Groundwater Application Review Summary Form

Application # G- 18575

PUBLIC INTEREST REVIEW FOR GROUNDWATER APPLICATIONS

TO: Water Rights Section Date 02/04/2019
 FROM: Groundwater Section Joe Kemper / Michael Thoma
 Reviewer's Name
 SUBJECT: Application G- 18575 Supersedes review of na
 Date of Review(s)

Figure 1. Water Availability Tables

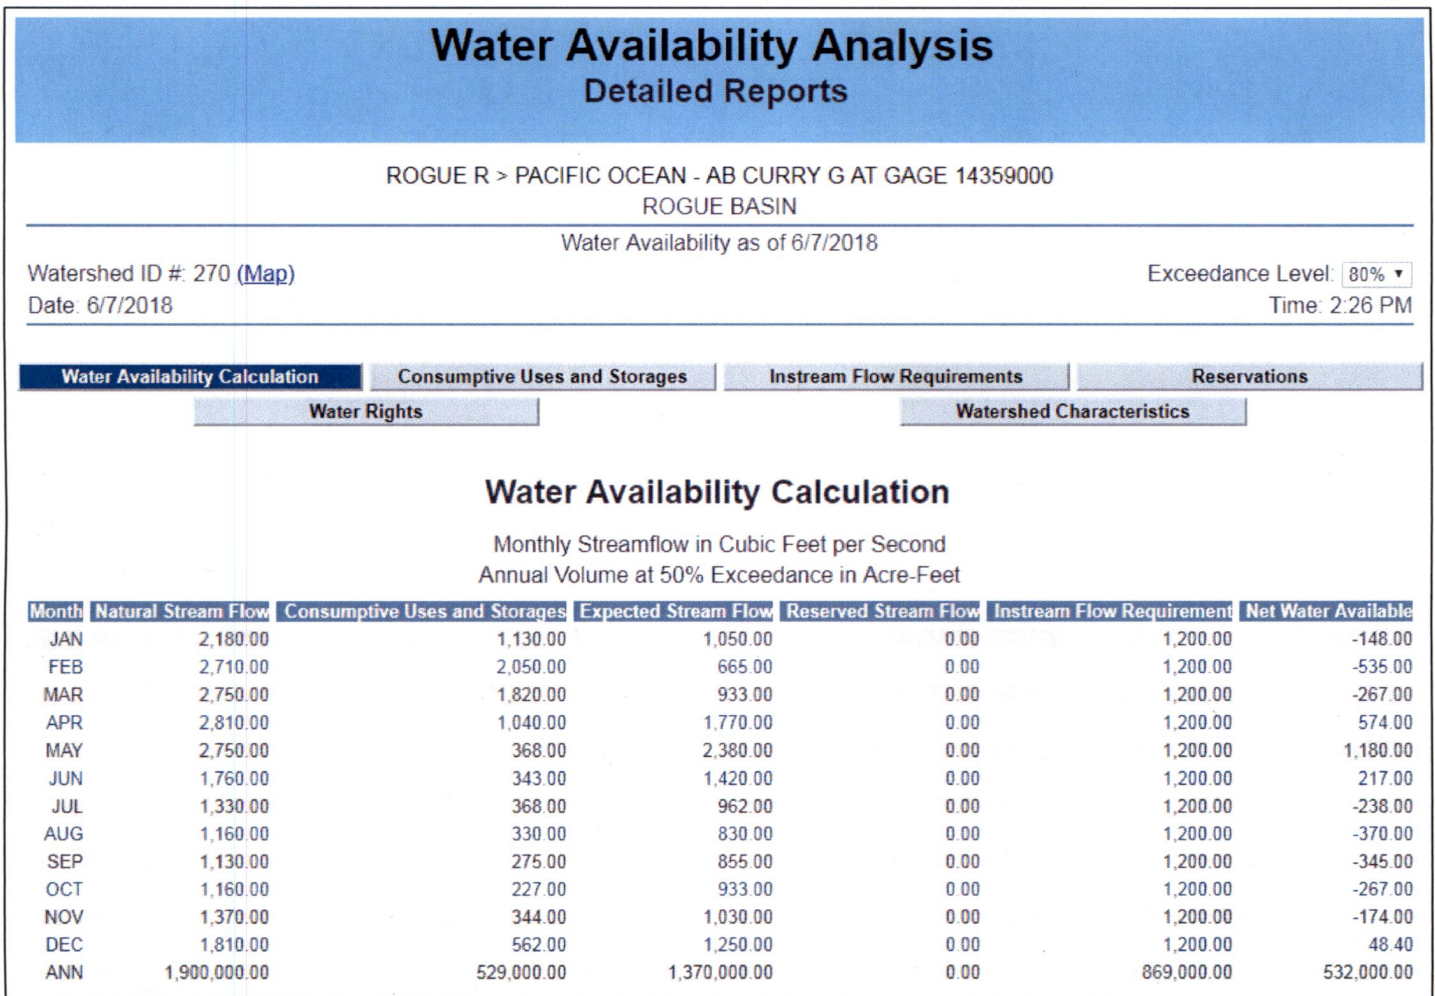
Non-Distributed Wells													
Well	SW#	Jan	Feb	Mar	Apr	May	Jun	Jul	Aug	Sep	Oct	Nov	Dec
2	2	See comments below*											
Well Q as CFS		0.05	0.05	0.05	0.05	0.05	0.05	0.05	0.05	0.05	0.05	0.05	0.05
Interference CFS		< 0.05	< 0.05	< 0.05	< 0.05	< 0.05	< 0.05	< 0.05	< 0.05	< 0.05	< 0.05	< 0.05	< 0.05
(A) = Total Interf.		< 0.05	< 0.05	< 0.05	< 0.05	< 0.05	< 0.05	< 0.05	< 0.05	< 0.05	< 0.05	< 0.05	< 0.05
(B) = 80 % Nat. Q		2180	2710	2750	2810	2750	1760	1330	1160	1130	1160	1370	1810
(C) = 1 % Nat. Q		21.80	27.10	27.50	28.10	27.50	17.60	13.30	11.60	11.30	11.60	13.70	18.10
(D) = (A) > (C)													
(E) = (A / B) x 100		<1 %	<1 %	<1 %	<1 %	<1 %	<1 %	<1 %	<1 %	<1 %	<1 %	<1 %	<1 %

Basis for impact evaluation: A pumping rate of 0.05 cfs over 365 days is used to simulate the requested 36 AF/year pumped continuously from a single well. Although the proposed aquifer is found to be hydraulically connected to both the Rogue River and Constance Creek, the two streams are within the same WAB, and thus the above calculations are compared only once to the WAB expected natural flows.

*Monthly stream-depletion was not estimated because the maximum pumping rate (0.10 cfs) and estimated average pumping rate (0.05 cfs) are far less than 1% of the monthly 80% Natural Flows. Actual stream-depletion will be less than the pumping rate.

Figure 3. Water-Level Trends in Nearby Wells

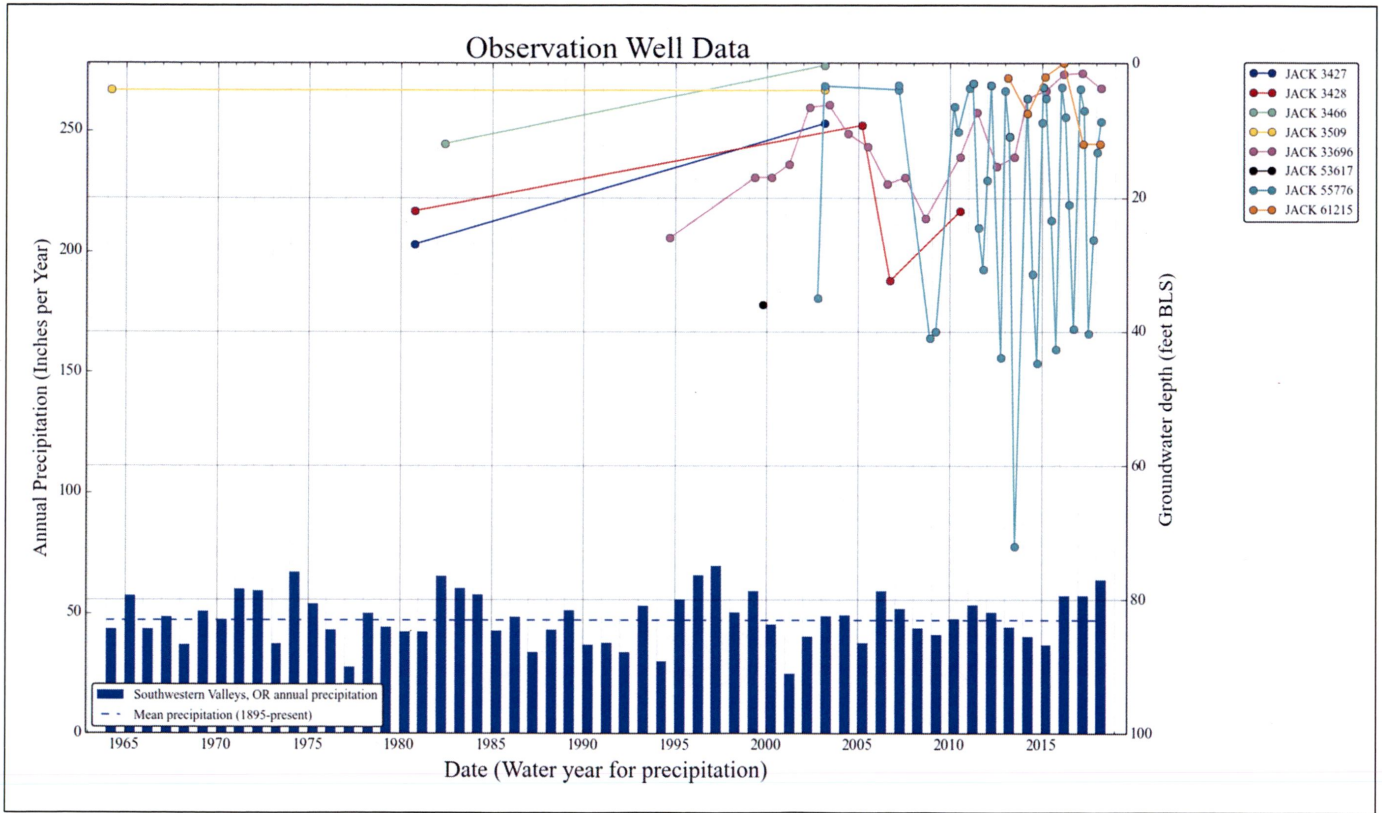
B3. **Groundwater availability remarks:** The applicant's POAs would produce from an aquifer hosted in fractured bedrock of the Payne Cliffs Formation. There are several OWRD observation wells accessing the Payne Cliffs Formation within 1 mile of the proposed POA (see Figure 3). Seasonal and annual water level trends do not conclusively indicate that new use would not be in the Capacity of the Resource.
